This Amendment and Request for Reconsideration is filed in response to the Office Action of **September 26, 2005**, in which claims 1-16 were rejected, the specification was objected to and the drawings were objected to by the Examiner.

## APPENDIX

Annotated Sheet Showing changes

FIG. 1

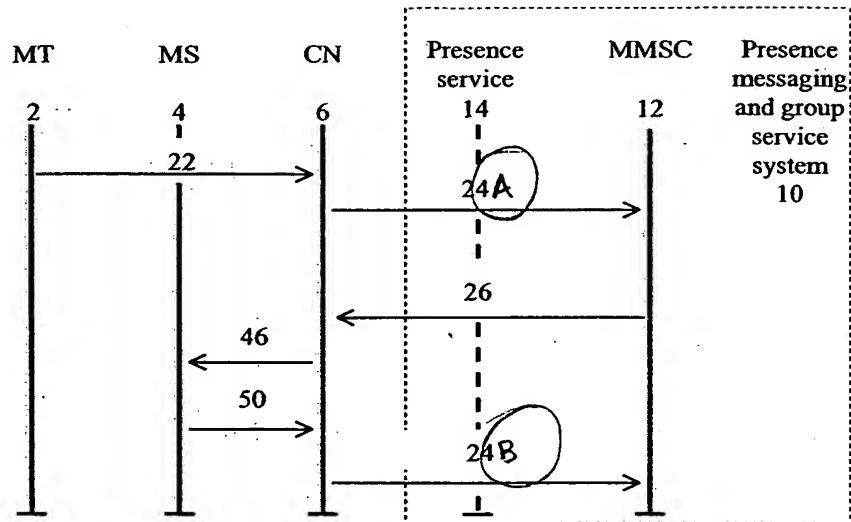
Included in an Appendix hereof is an annotated sheet showing changes as well as a replacement sheet. The changes involve the reference numeral 24 with new designations as -- 24A -- and -- 24B -- instead of just plain "24" in two instances where the same reference numeral is associated with different signal lines. Approval is requested.

Regarding the objection to the drawings, an amendment thereto has been made above and the reference numeral 24 has been changed in both Figures 1 and 2 to differentiate between the two instances shown in both Figures 1 and 2 by naming one signal line 24A and the other 24B. A replacement sheet has been included in the Appendix which incorporates the proposed changes and which complies with 37 CFR 1.84. In both Figures 1 and 2 the first reference numeral "24" has been replaced with -- 24A --. The second instance of the reference numeral "24" in both Figures 1 and 2 has been replaced by -- 24B --. It is believed that this complies with the Examiner's requirement and withdrawal of the objection is therefore requested.
